Unit 1-H Existing Floor Plan Enlargement

Unit 1-H Proposed

PROJECT	VILLAMORIS CONDOMINIUM
111 PINE ST.	PORTLAND, OREGON, 97204
OWNER	WILLAMORIS CONDOMINIUM ASSOCIATES
DESIGNER	WILLAMORIS CONDOMINIUM ASSOCIATES
DATE	02/05/2019
SCALE	1/8" = 1'-0"
DRAWN BY	JAN SHIHO

Project Name WILLIAMSBURG 1H REMODEL

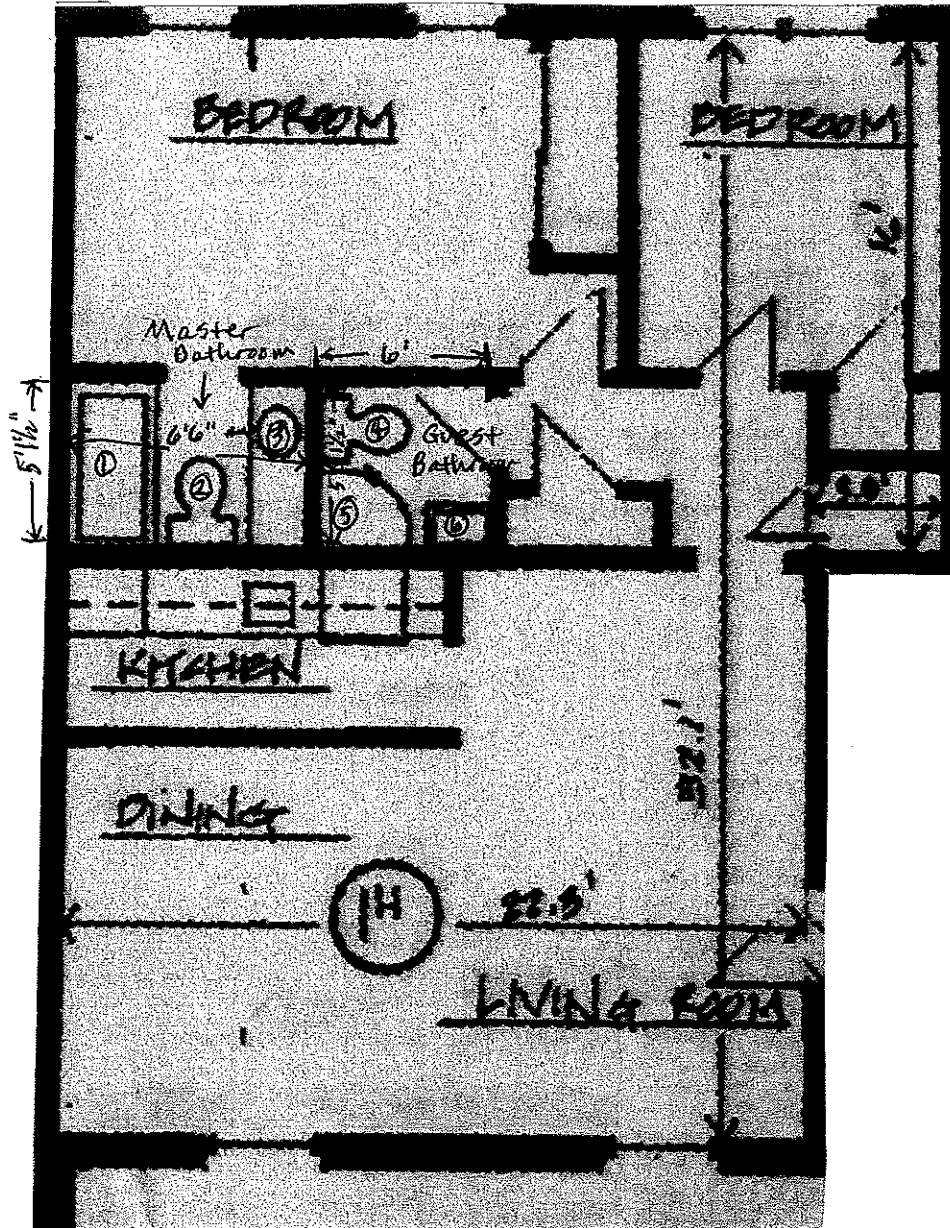
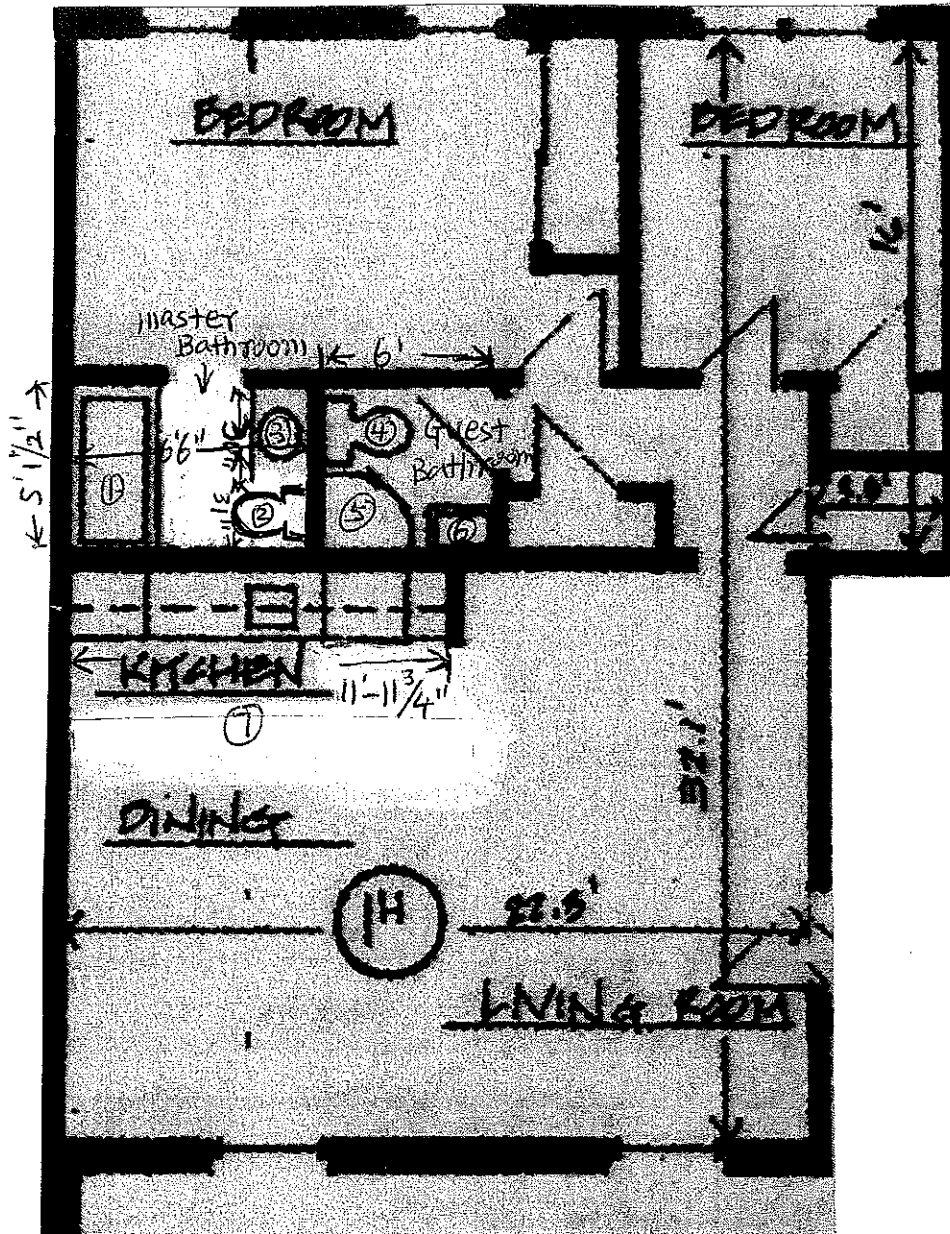
Note: both bathrm. dimensions to stay the same
Master Bathrm. dimensions: 5'1 1/2" x 6'

Guest Bathrm. dimensions: 5'1 1/2" x 6'

Existing
 *Ceiling height for
 unit 1-H : 8' - to stay the same

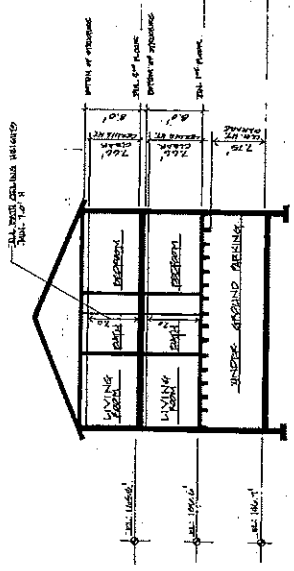
Note: The master Bathroom dimensions
 between sink and toilet 5'1"

Door 175B

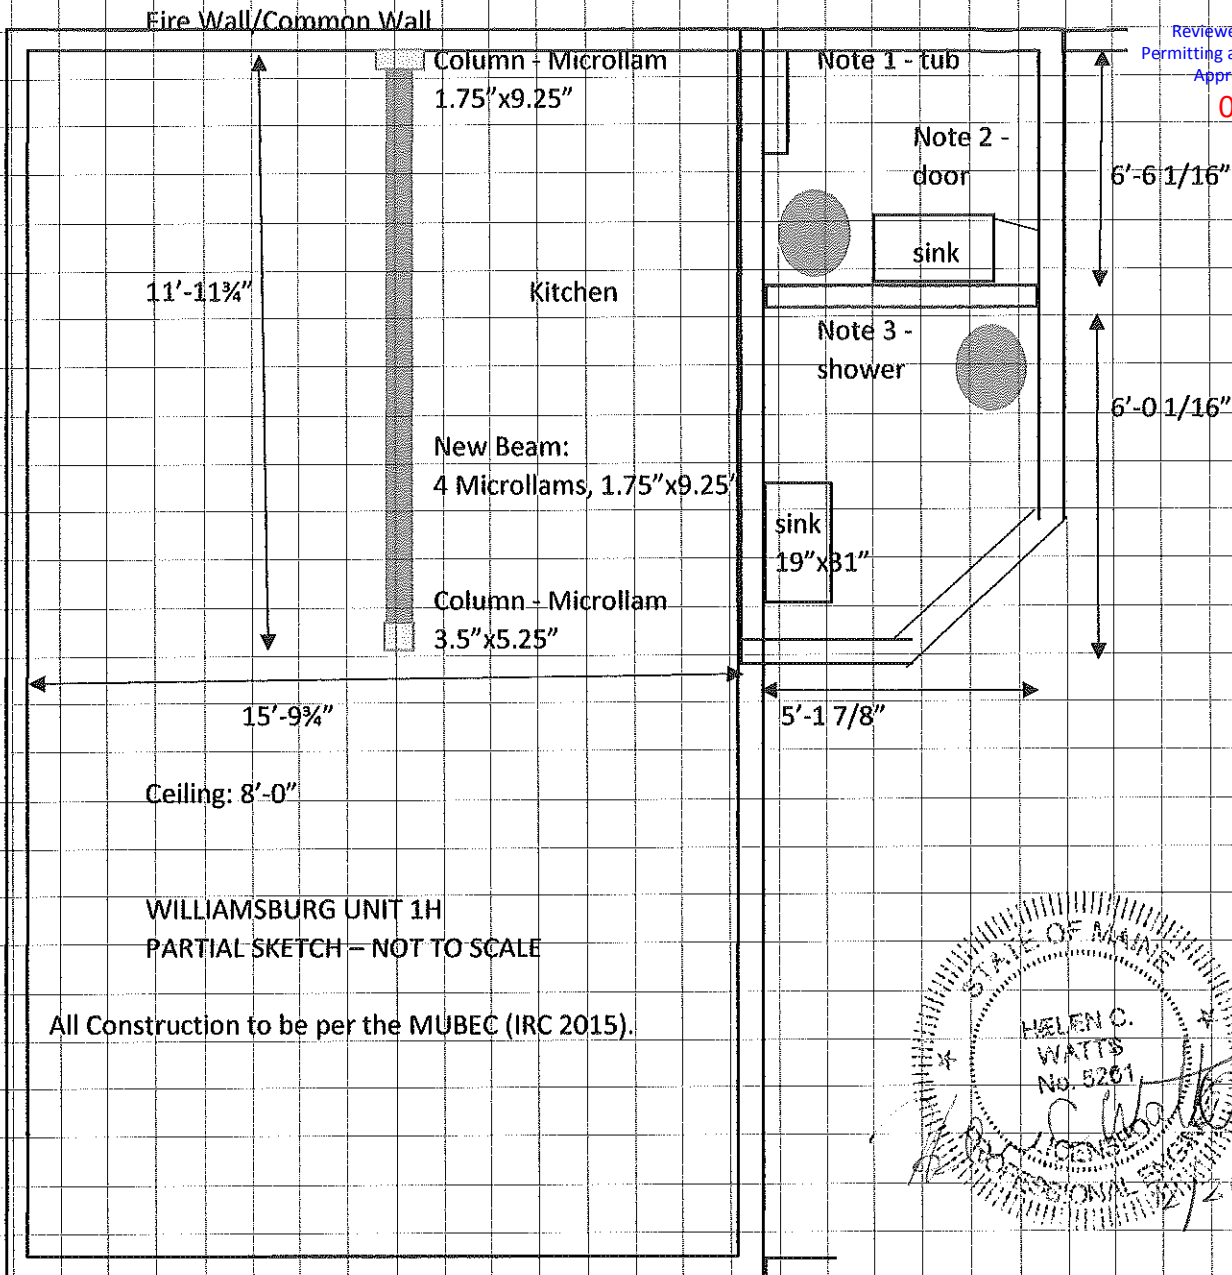
Note 1: The enclosed space non-structural and can be removed to install a longer tub.

Note 2: The door swings in. This can't be replaced with a pocket door without adding a header above. The door can be reinstalled to swing out.

Note 3: Re-measure the bathroom before finalizing design. Check with plumber for relocating plumbing due to concrete slab/T-beams below.

Provide temporary support for the framing above before removing the wall between the kitchen and the living room.
